Addendum No. 001

Subject: Mechanical Plant Replacement Bid Package
Mechanical
SDP Contract No. B-045 (c) of 2017/18

Location: Arts Academy at Benjamin Rush
11081 Knights Road
Philadelphia, Pennsylvania 19154

DRAWING NO.
CS-001

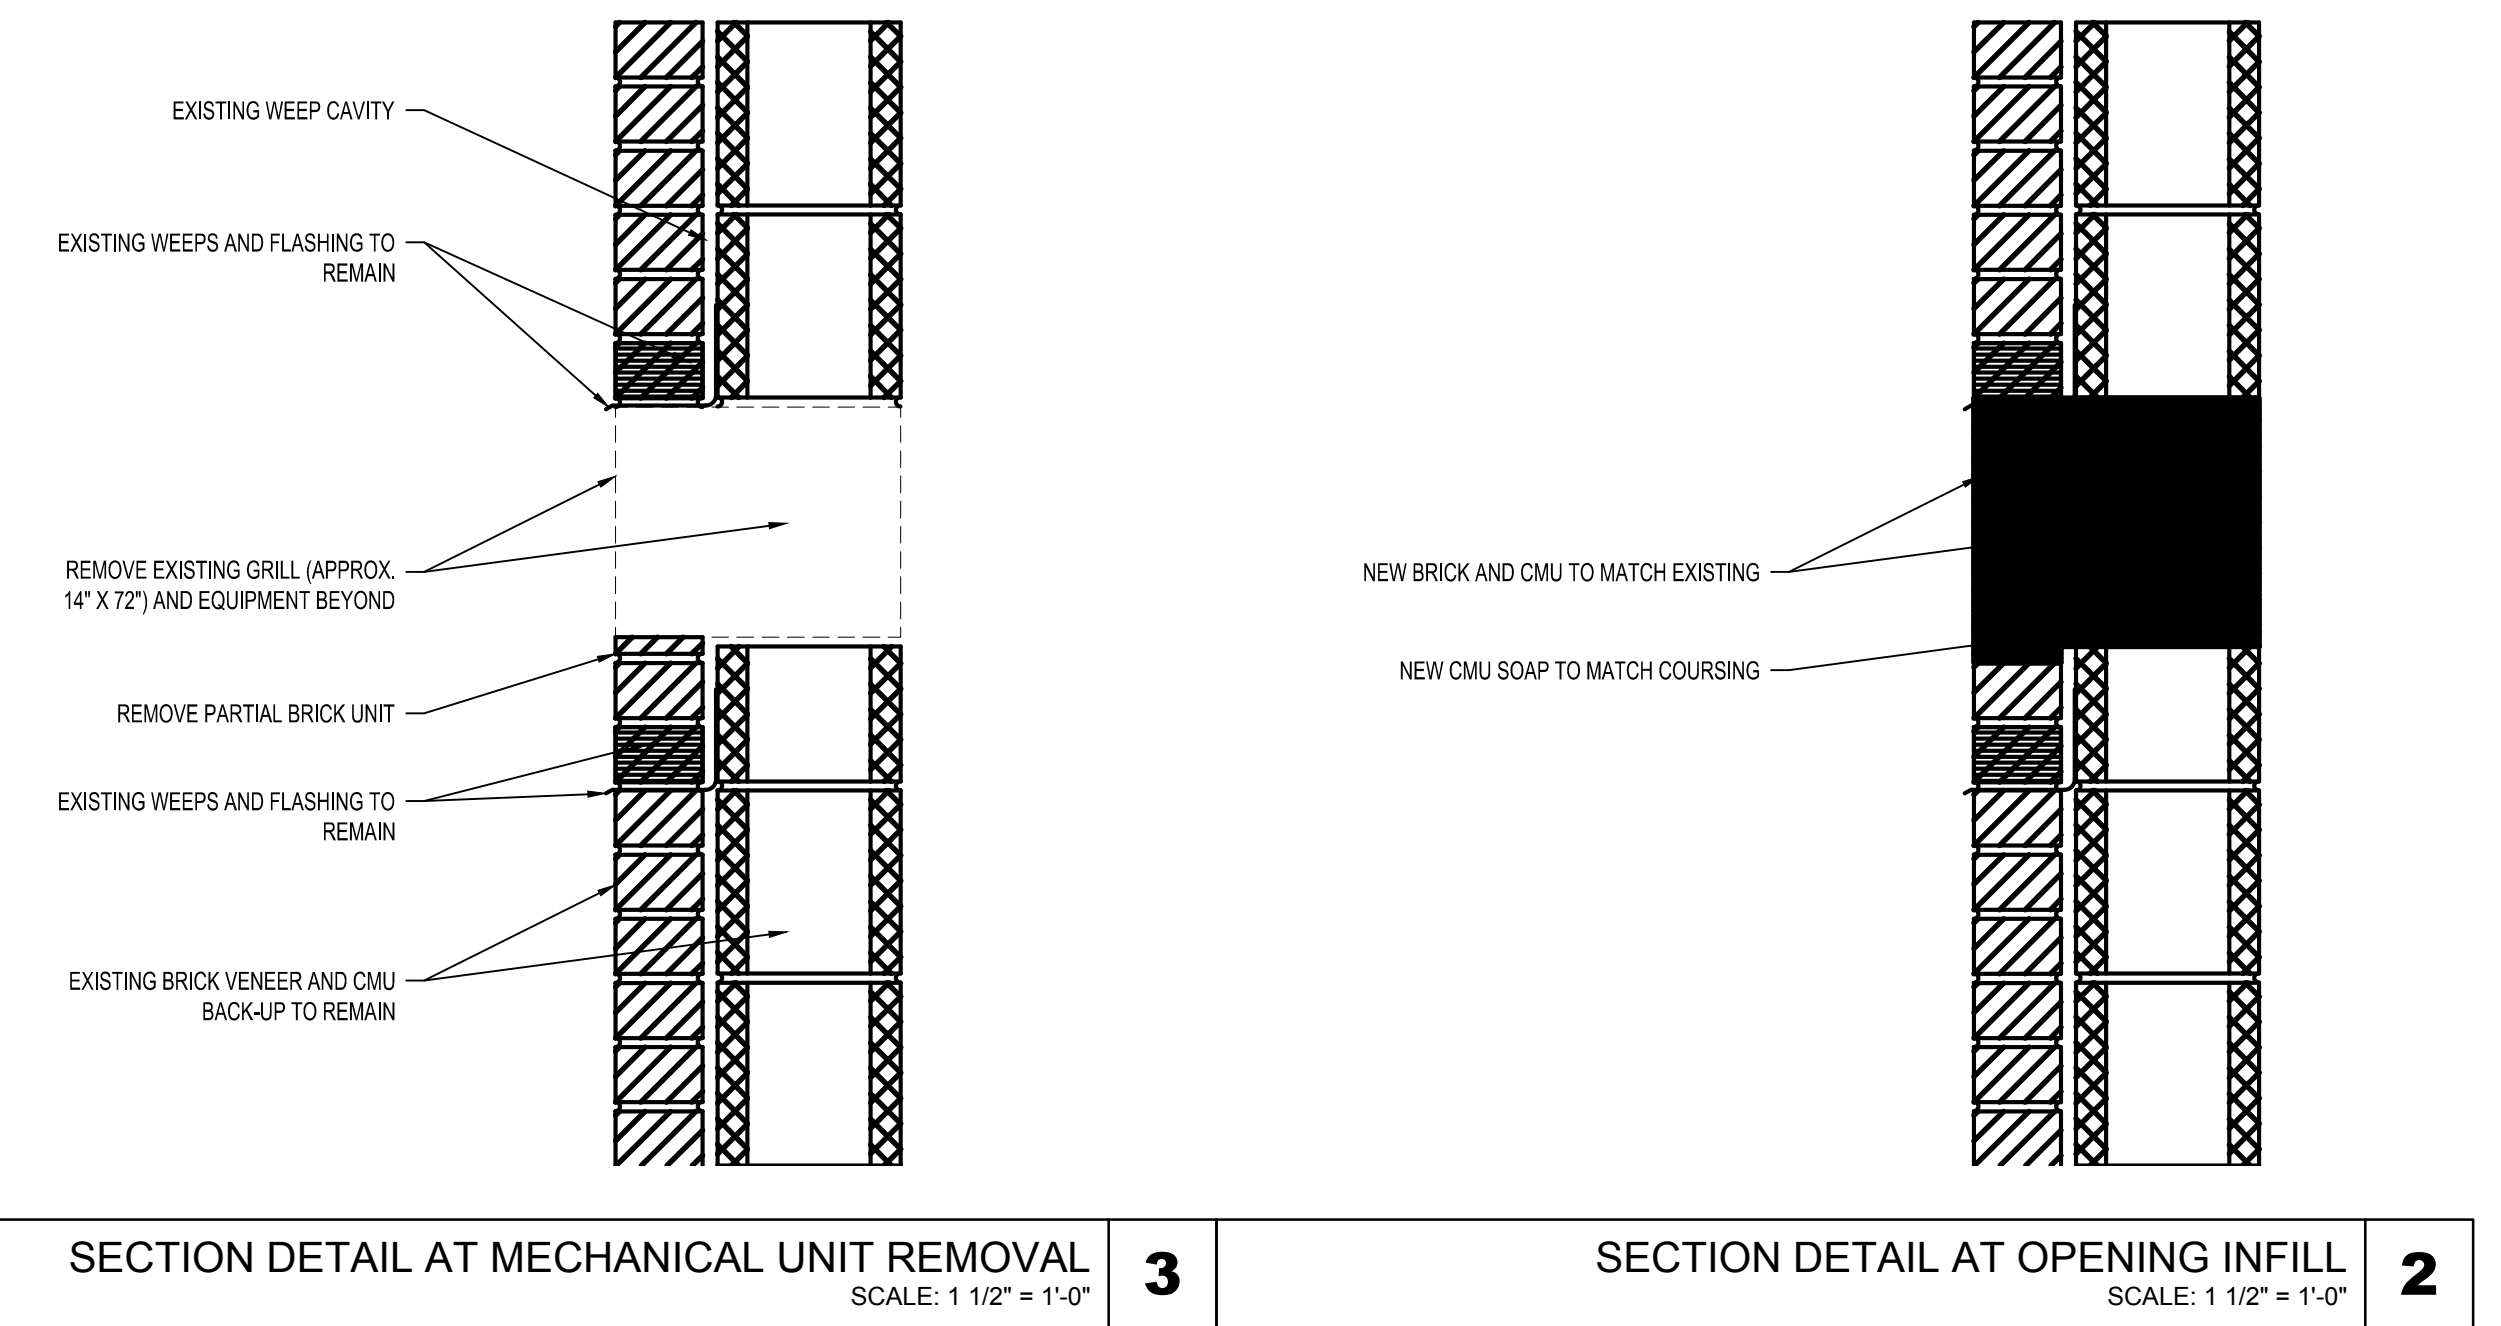
- 2.1.1** Drawing revision CS-001 – Revised Drawing Updated drawing list and issue log.
- 2.1.2** Drawing revision A100 – Revised Sheet Notes 1 to include noting for carpet repair/infill.

DRAWING NO.
A100

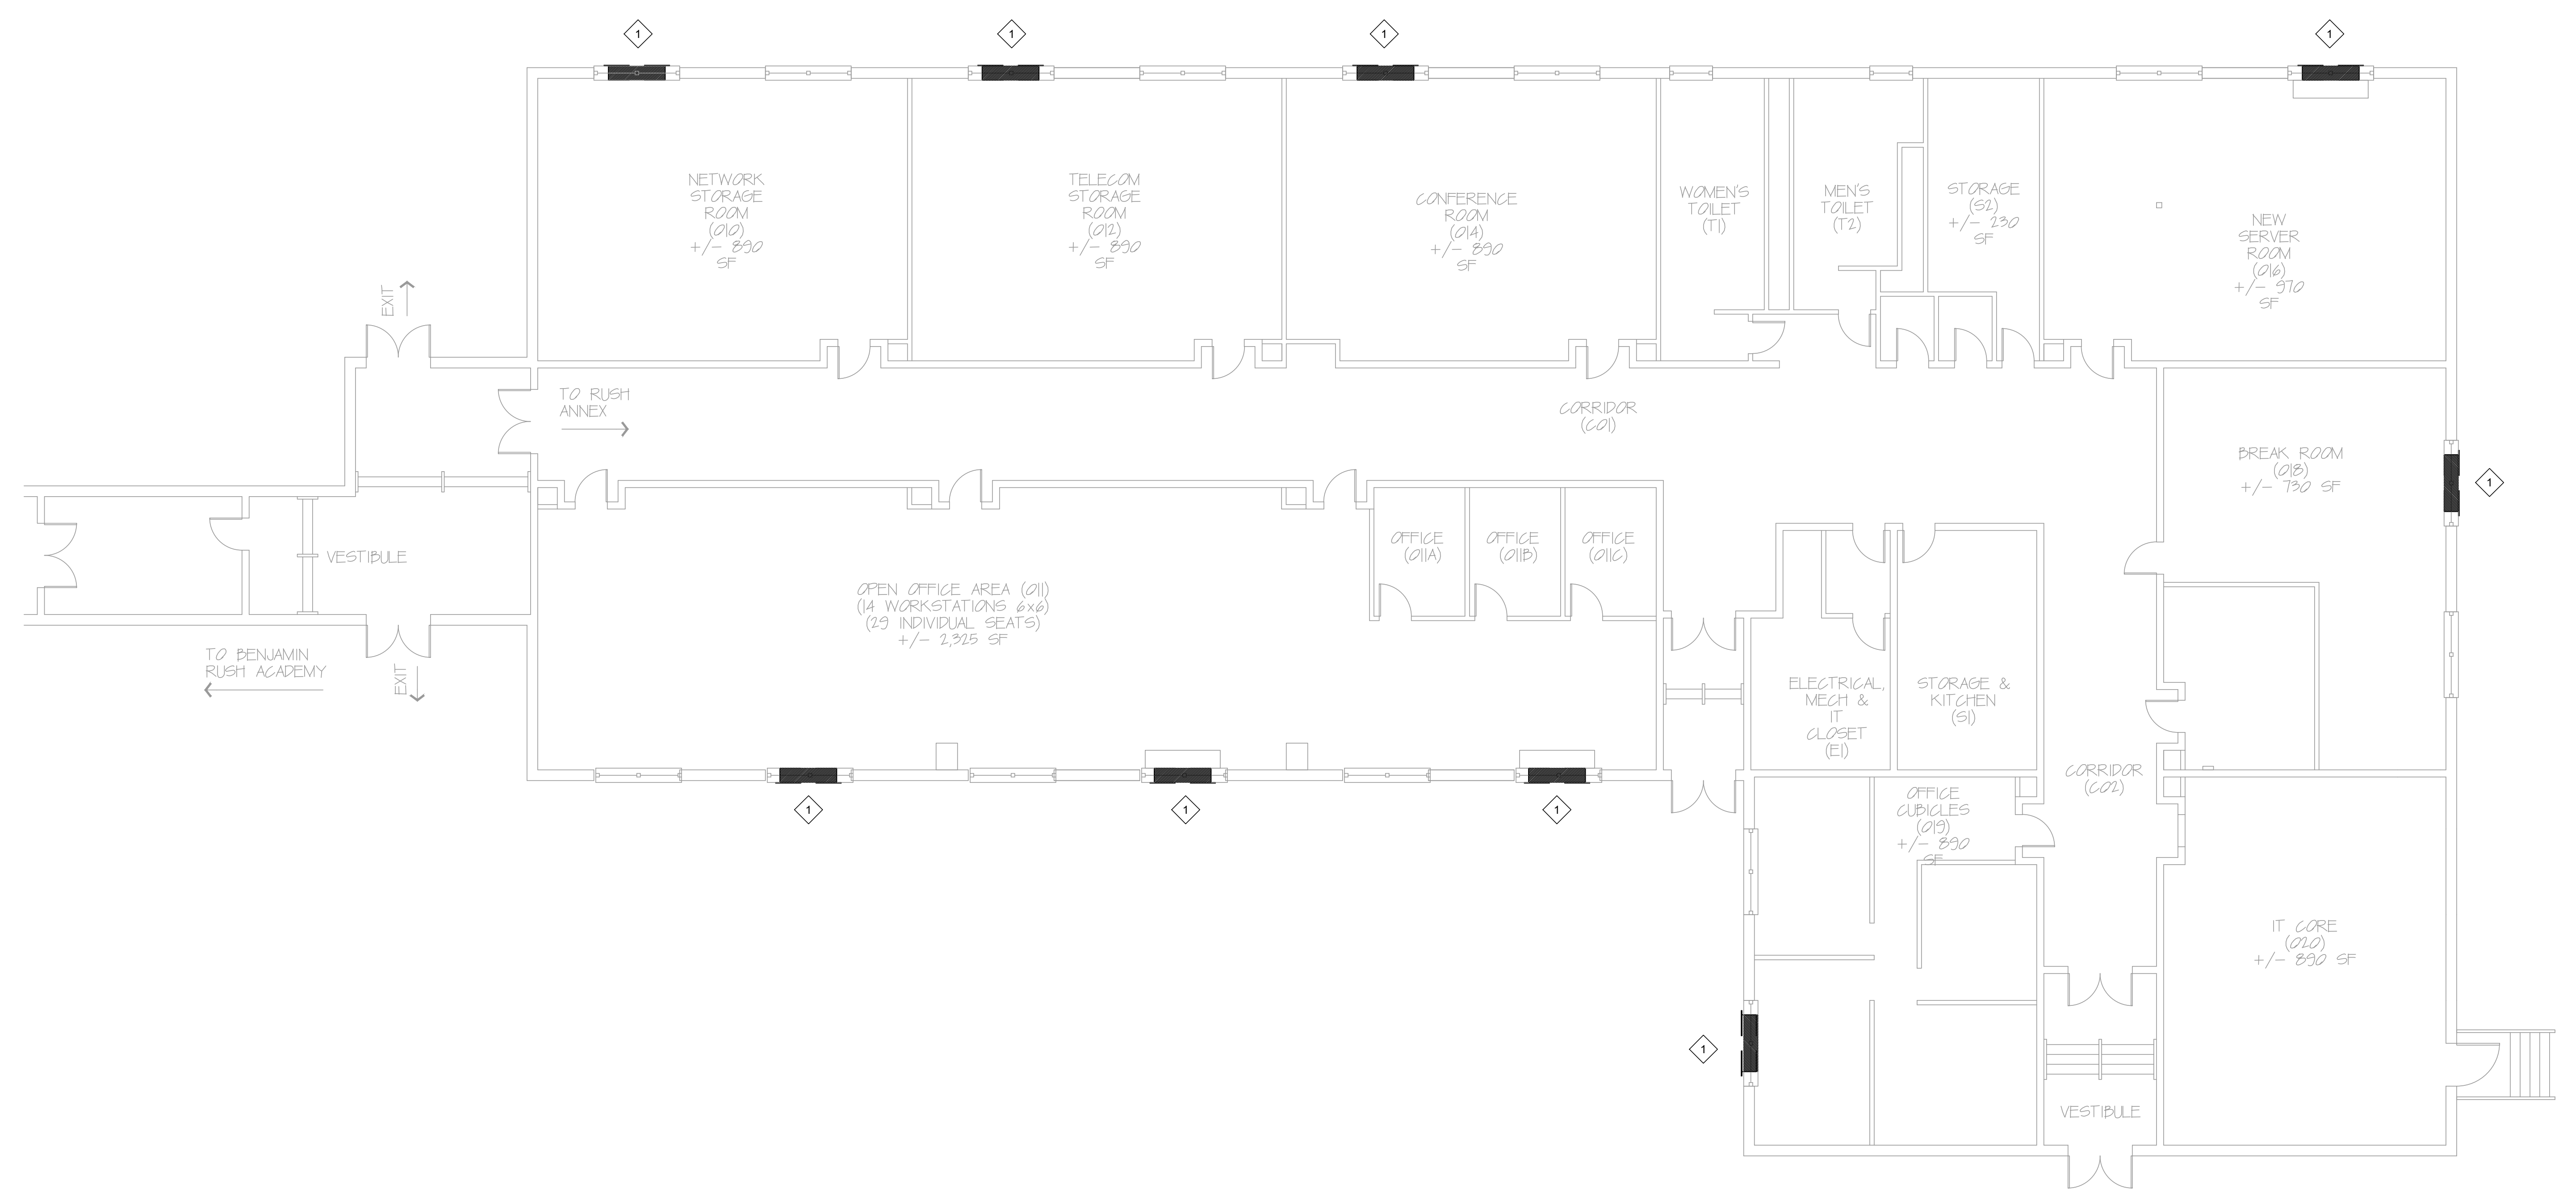
3.1.4 Is floor patching required at the unit ventilator locations? If so, what is the manufacturer, model and color of the flooring?

- Refer to 2.1.2 above; carpeting specification attached.

1 REMOVE THRU-WALL MECHANICAL UNITS AND GRILLS. INFILL EXISTING OPENING WITH BRICK AND CMU TO MATCH EXISTING MASONRY. FOLLOW EXISTING COURSING. SEE SECTIONS 2 AND 3A100 FOR DETAILS. PAINT INTERIOR TO MATCH EXISTING IN COLOR, TEXTURE AND SHEEN. INFILL EXPOSED FLOOR AREA WITH CARPET TILES TO MATCH EXISTING. REPLACE PARTIALLY CUT EXISTING TILES WITH WHOLE TILES WHERE APPROPRIATE TO EFFECT A CONSISTENT APPEARANCE.
